NFPA 101 EXIT DISCHARGE.

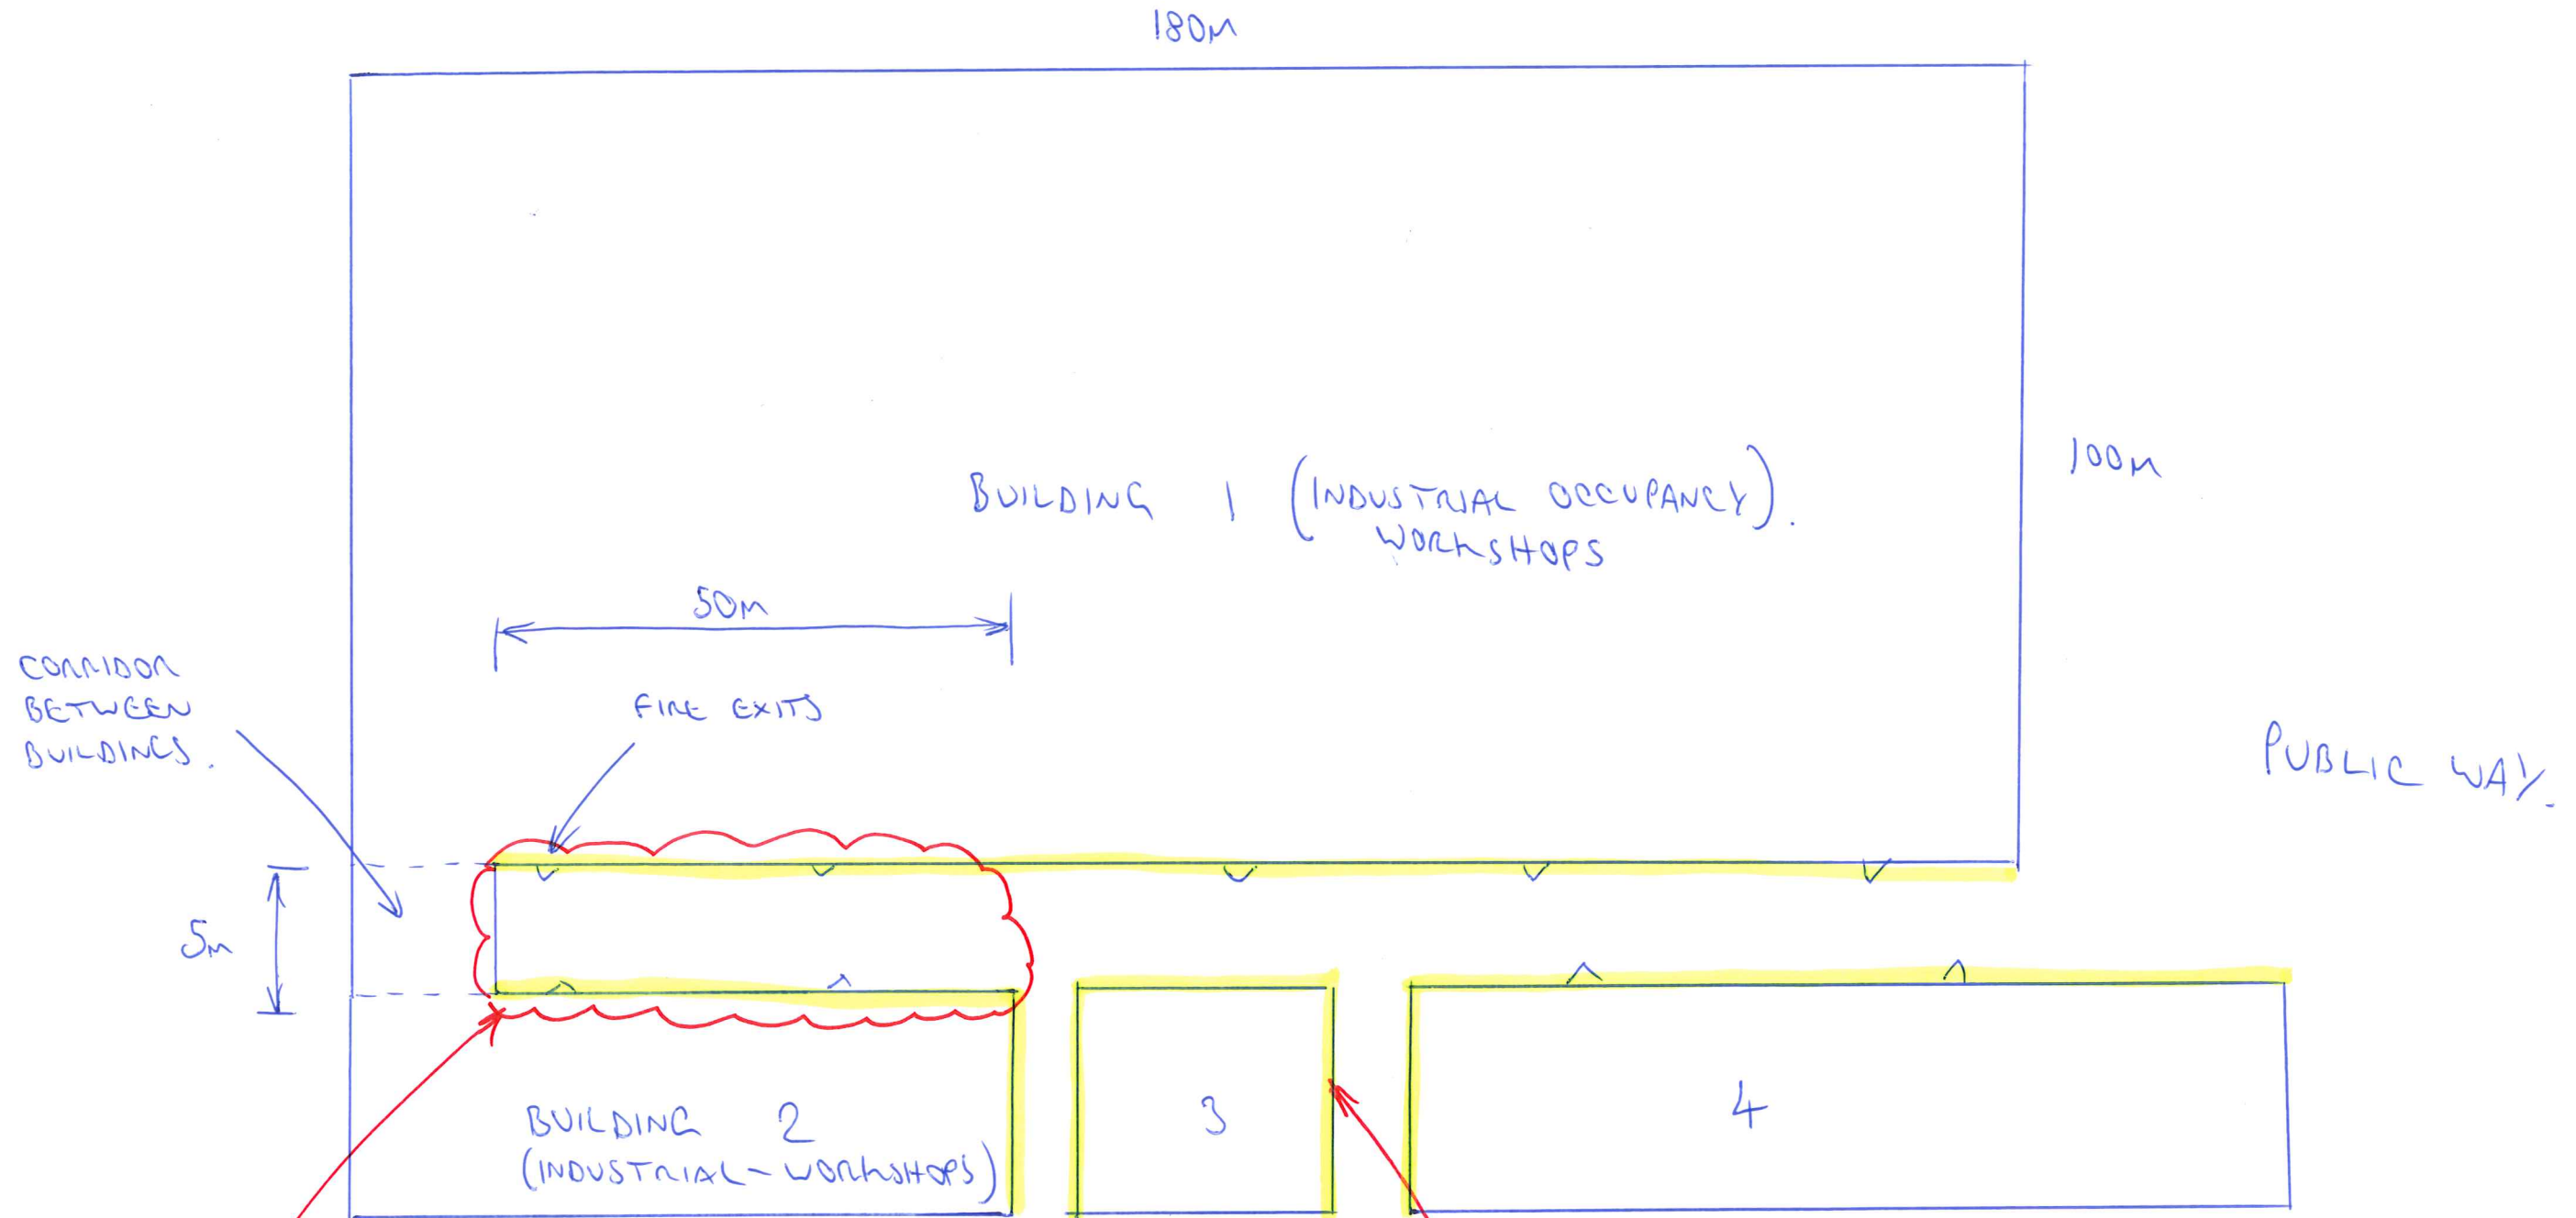
AREA OF
CONCERN
DEAD END SPACE
BETWEEN BUILDINGS

MUST THESE WALLS BE FIRE RATED
TO PROTECT PEOPLE USING THESE
ALLEYS TO EXIT TO THE
PUBLIC WAY?
